Village of Arlington Heights
Conceptual Plan Review Committee
Virtual Meeting
November 18, 2020
6:30 PM

VILLAGE OF ARLINGTON HEIGHTS **STAFF DEVELOPMENT** **COMMITTEE REPORT**

Temp File Number: T708
Project Title: Arlington 425 PUD Amendment
Address: Northern portion of Block 425
PIN: Multiple PIN's

**Re: Request for Concept Plan Review of Revised Plat of Resubdivision and
Planned Unit Development of the Arlington 425 Development**

ARLINGTON 425: 225 W. CAMPBELL NORTH ELEVATION

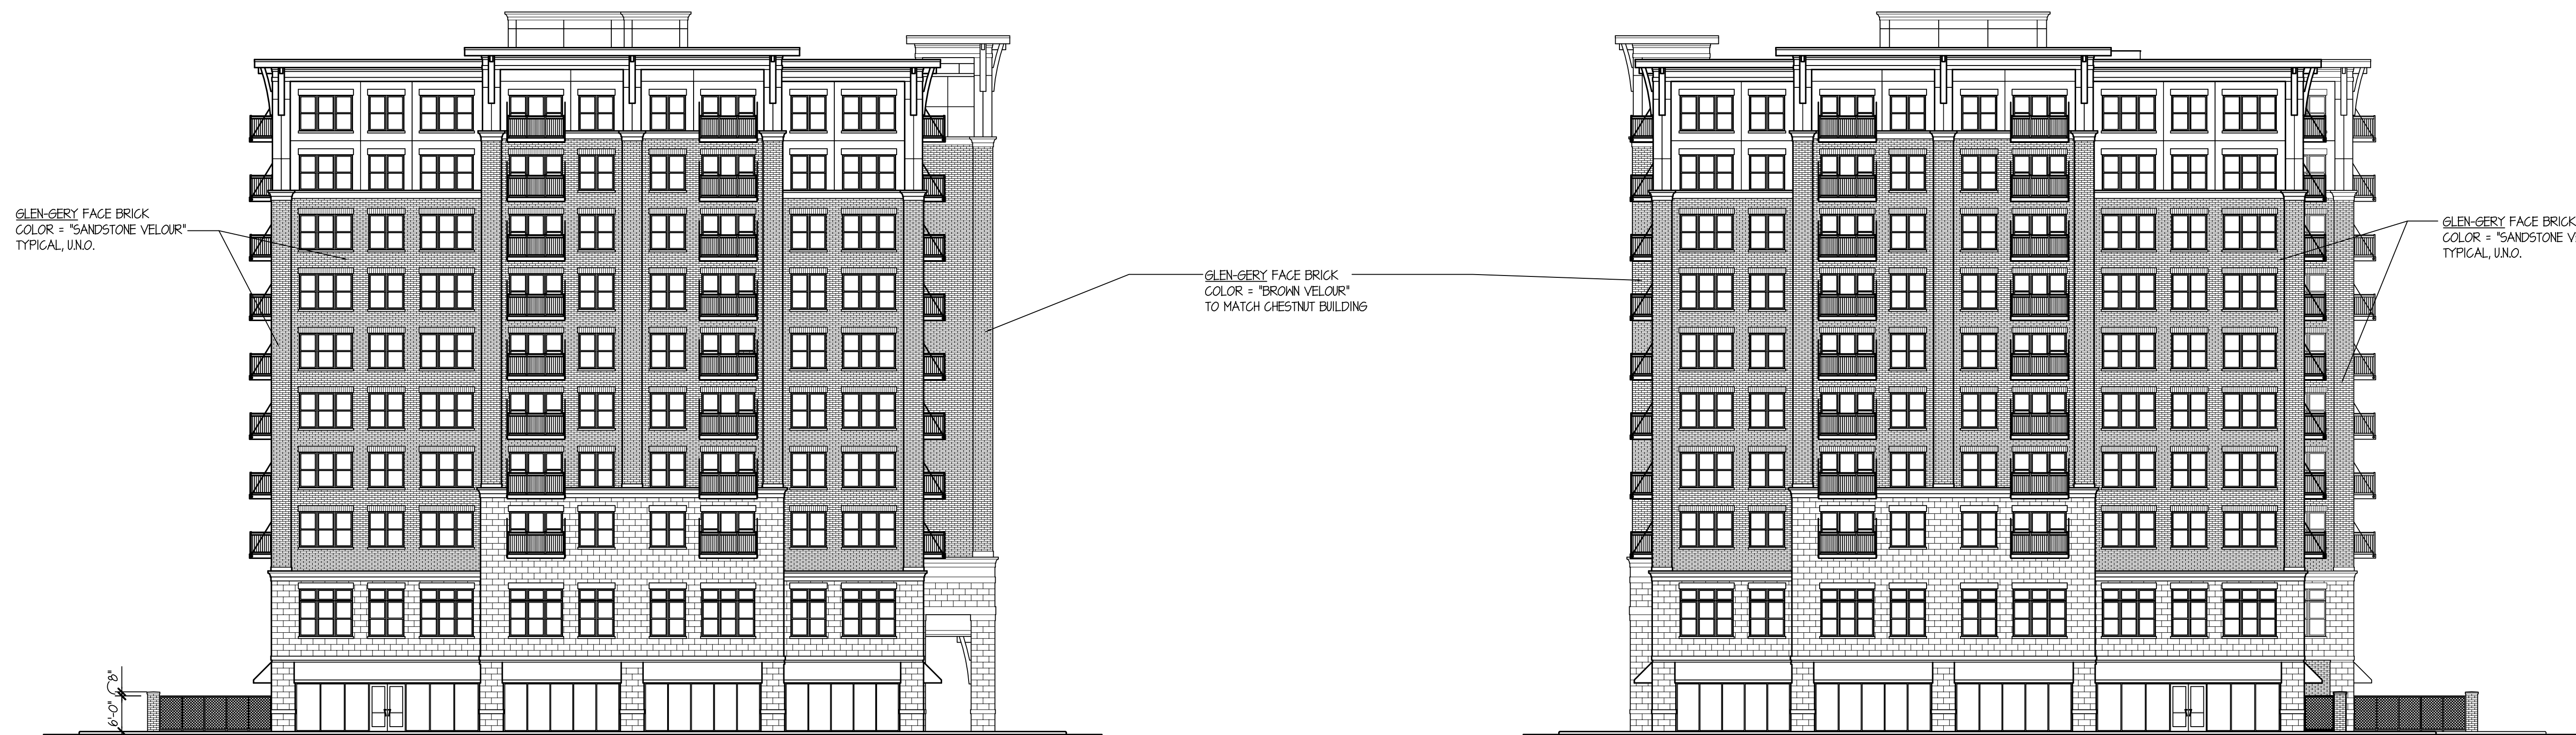
The Campbell building is substantially consistent with the height guidelines outlined in the Downtown Master Plan, which call for a maximum building height of eight stories. While the proposed 10-story height is slightly above the recommendation within the Downtown Plan, in the context of the reduction in height of the 13-story Highland Building, the proposed increase in height is acceptable. Staff notes that the property directly west of the Campbell building is zoned for multi-family uses, and the properties to the north and east are mid-rise buildings of a compatible scale.

ARLINGTON 425: 33 S. CHESTNUT WEST ELEVATION (ORIGINAL APPROVED ELEVATION)

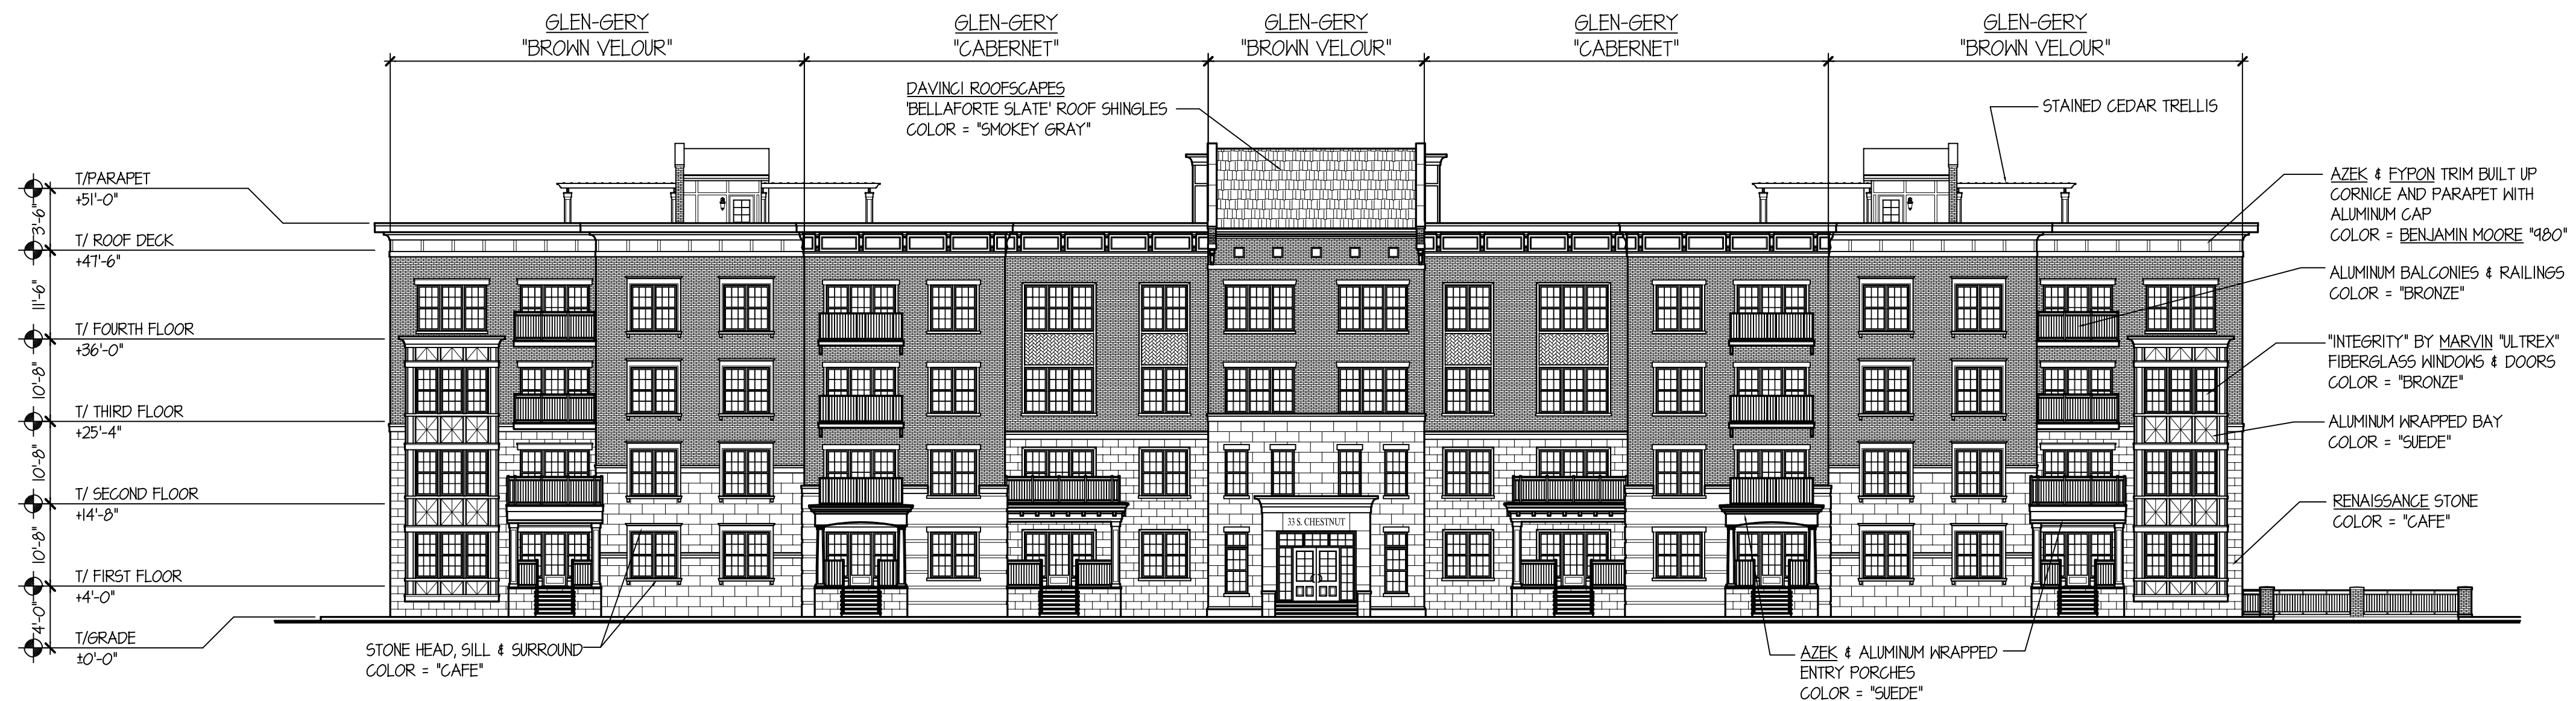
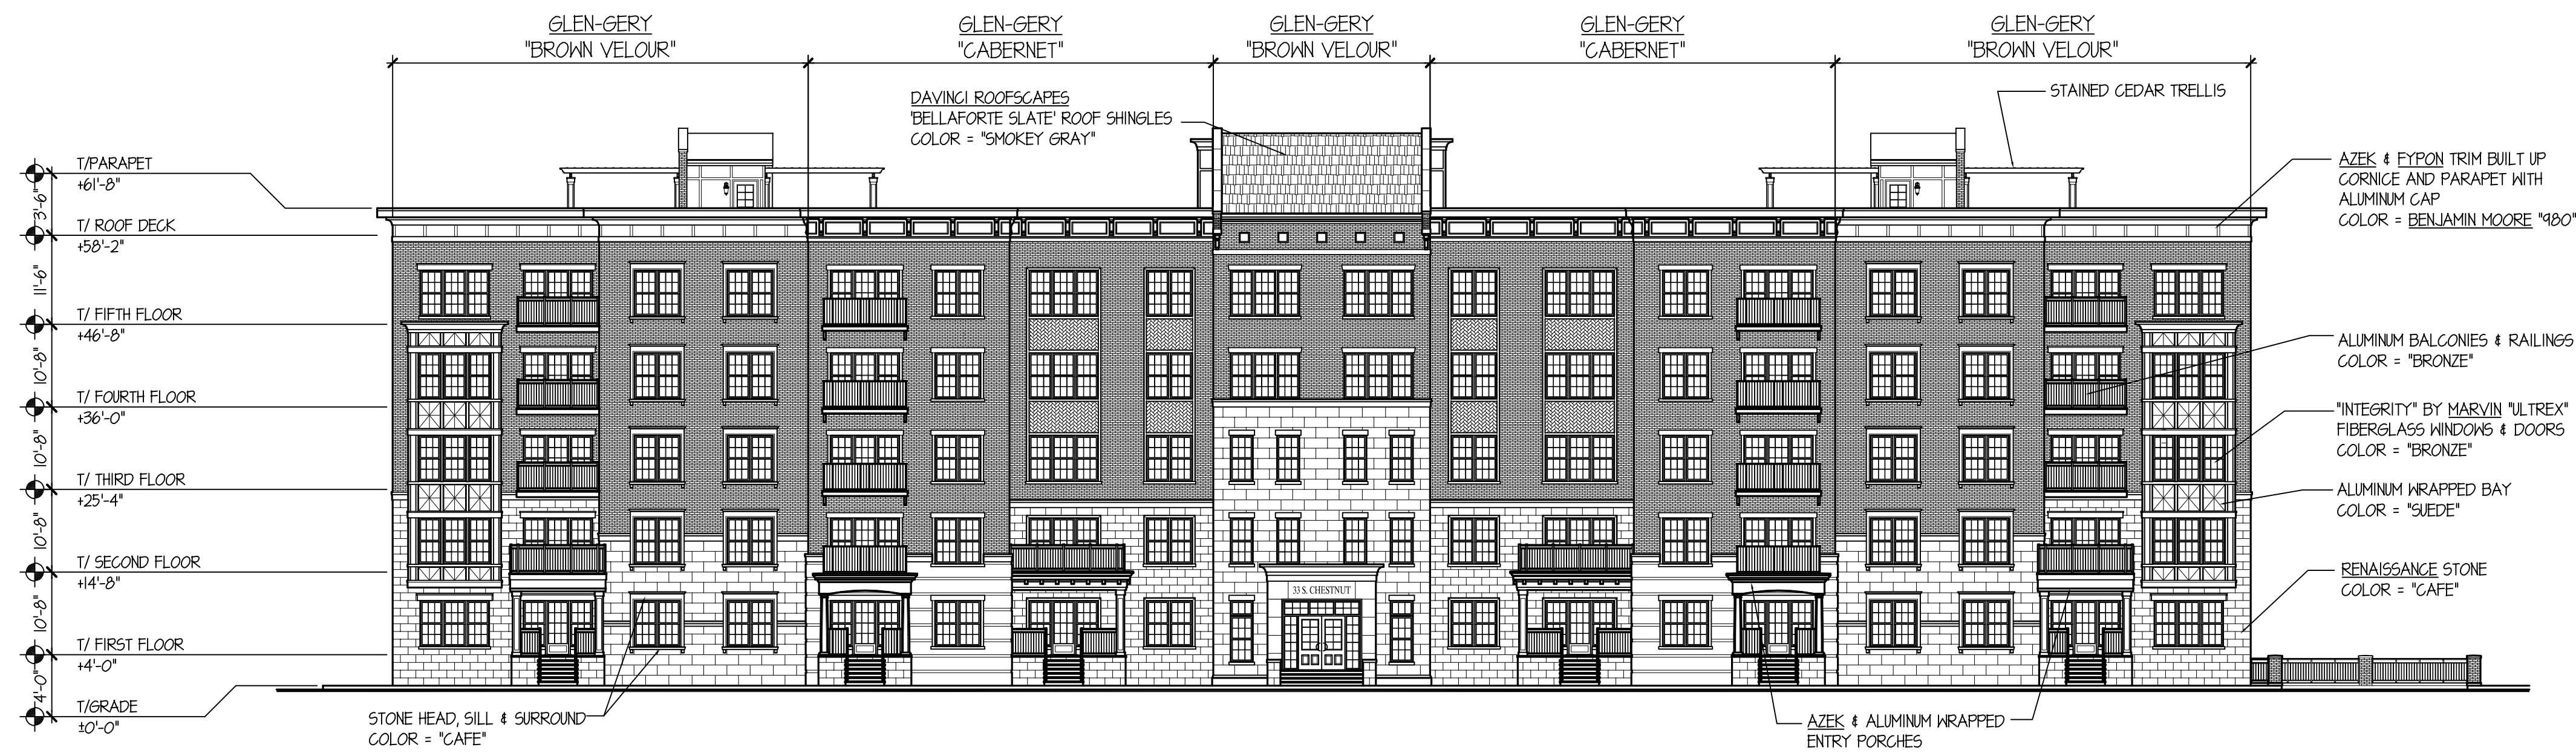
The proposed 1-floor height increase to the Chestnut building, yielding an overall building height of five floors, is reasonable and compatible with the height standards within the Downtown Plan. The petitioner will

need to clarify where residents of the Chestnut building will park, given that the proposed underground parking within that building will no longer be constructed. Additionally, prior to appearing before the Plan Commission, the petitioner shall hold a “virtual” neighborhood meeting to introduce the proposed amendments to the neighboring residents and business owners.
